Subject: Comments on "Performance-Based Emergency Core Cooling Systems Cladding Acceptance Criteria" (Docket ID NRC-2008-0332) (*Federal Register* Notice 79FR16106)

Industry Response to 10CFR50.46c Draft Rule Language

Figure 4.1: Regulatory Issues Implementation Cost Comparisons

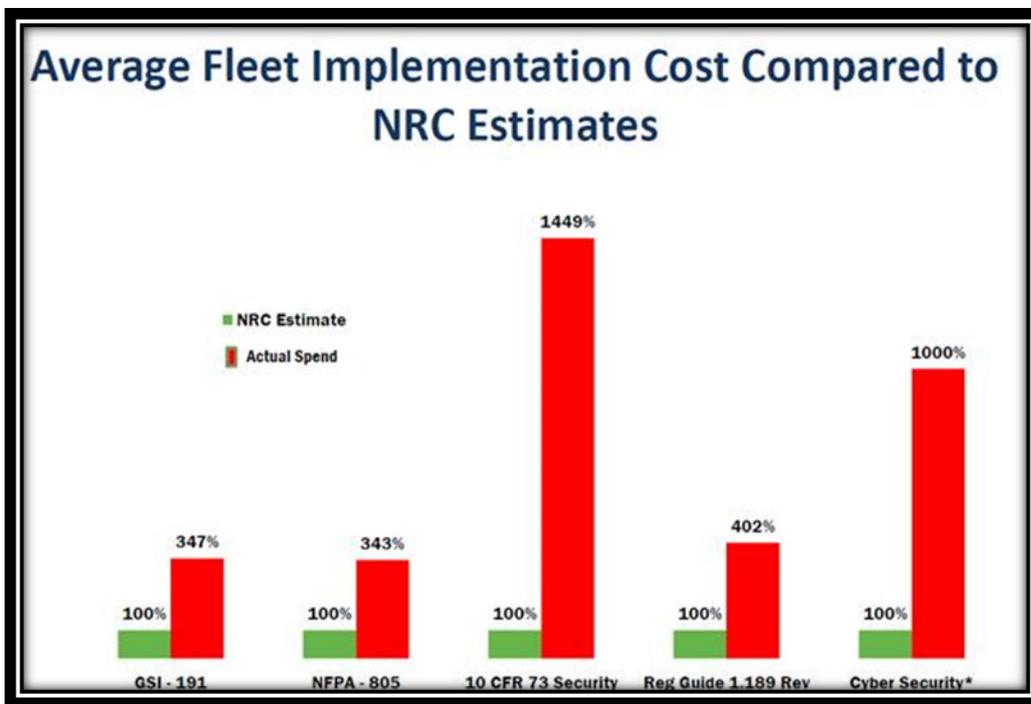
Based on the statement in the regulatory analysis, using the “adequate protection justification” as a basis for not entering the backfit analysis provision per 10 CFR 50.109(a)(4)(ii), industry does not agree that the entire content of the proposed rulemaking meets the backfit requirements. Industry believes NRC should perform a realistic review of the cost of the proposed rule and consider the inaccuracies identified in the regulatory analysis. The overall perception by the industry is that the NRC’s cost estimates for industry activities is substantially below current estimates. This perception has been confirmed by both the industry review and in a recent NEI study comparing actual vs. estimated cost for previous regulatory issues (see Figure 4.1), showing a consistent, significant, under estimation of actual costs. Refer to Chapter 5 of this report for the detailed industry comments.

Table A.50: Specific Rule Language Comment 50

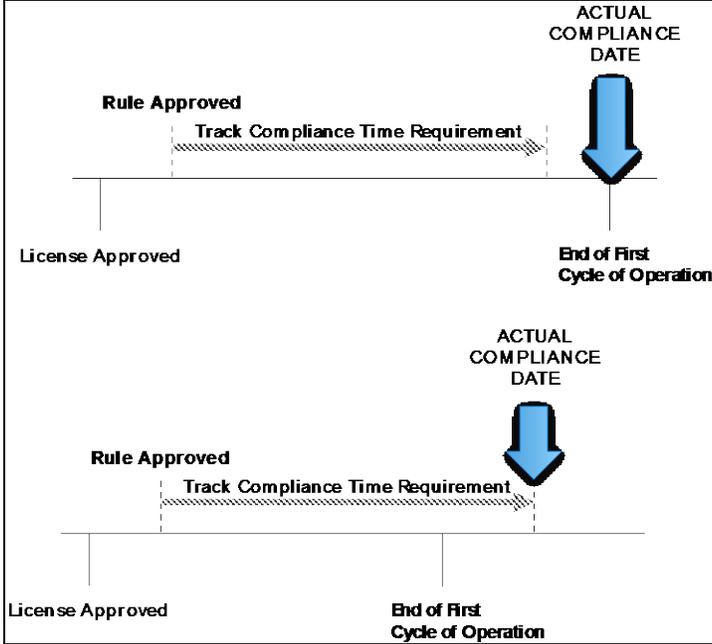
Comment	The current implementation plan has only one compliance date for each track. A phased implementation plan that allows different dates for different rule requirements is more appropriate. As a minimum a separate date is required for compliance with the long-term cooling requirements.
<i>Rationale</i>	<i>The industry proposes that the implementation rule language be revised to adopt a phased implementation approach. In this manner the various requirements in the rule can be evaluated to determine a realistic schedule for compliance given industry and NRC resource limitations. In particular the new debris based core cooling requirement is considered to involve a substantial work effort by industry and there is significant regulatory uncertainty due to the unavailability of a regulatory guide.</i>
Proposal	<p>NRC and industry would identify the list of requirements in 50.46c and agree on a phased implementation plan with schedules for individual or combinations of requirements. A template will be developed to standardize the industry response.</p> <p>As a minimum, a separate schedule for debris effects on cooling compliance is needed.</p>

<i>Justification</i>	<p><i>Phased implementation plans have been used successfully for previous regulatory issues. The Enhancements to Emergency Preparedness Regulations (NRC-2008-0122 / 76 FR 72560) allowed individual compliance dates for specific sections of the revised rule. The Power Reactor Security Requirements (NRC 2008-0019 / 74FR 13926) allowed for individual compliance dates for specific requirements. Implementation of rules does not require schedule dates in the rule language. Including schedule dates is likely to generate exemption requests and needlessly consume NRC and industry resources.</i></p> <p><i>The current state of the debris effects on core cooling aspects of the rule will require a later compliance schedule as there are significant unknowns at this time.</i></p>

Table A.52: Specific Rule Language Comment 52

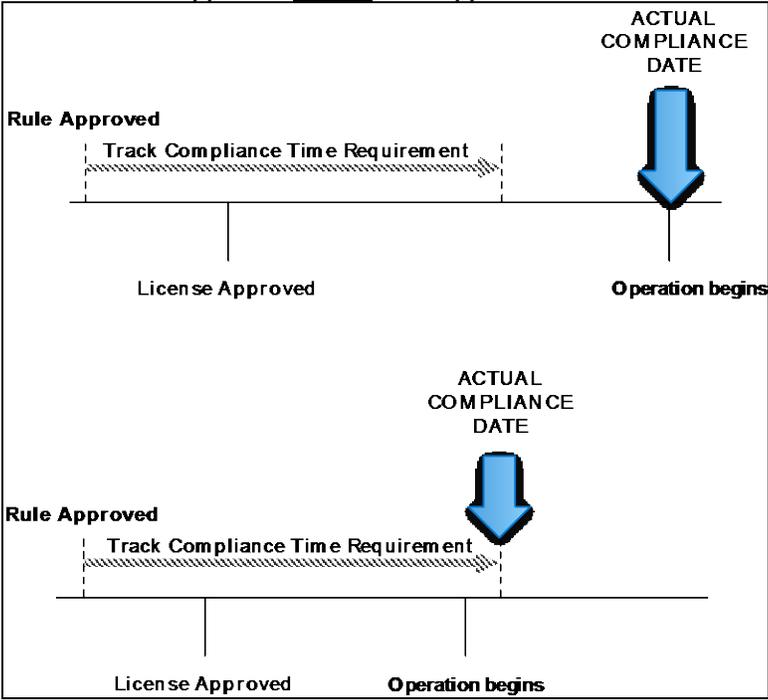
<p>New or Combined License Approved <u>AFTER</u> Rule Approved:</p> 
<p><i>Rationale</i></p>	<p><i>Unclear timing of compliance for new plants during first fuel cycle.</i></p>
<p>Proposal</p>	<p>Combined licenses issued under Part 52 of this chapter, before [EFFECTIVE DATE OF RULE] and combined licenses issued after the [EFFECTIVE DATE OF RULE] whose applications were docketed before [EFFECTIVE DATE OF RULE] must comply with this section no later than completion of the refueling outage after the first fuel cycle following [EFFECTIVE DATE OF RULE], or 12 months following [EFFECTIVE DATE OF RULE], whichever occurs later. Until such compliance is achieved, the requirements in § 50.46 continue to apply</p>
<p><i>Justification</i></p>	<p><i>The change in the implementation date would allow for the COL holders of a Part 52 license to have similar period of time to come into compliance with the proposed changes, similar to timeframes associated with Track 1 Plants from the proposal</i></p>
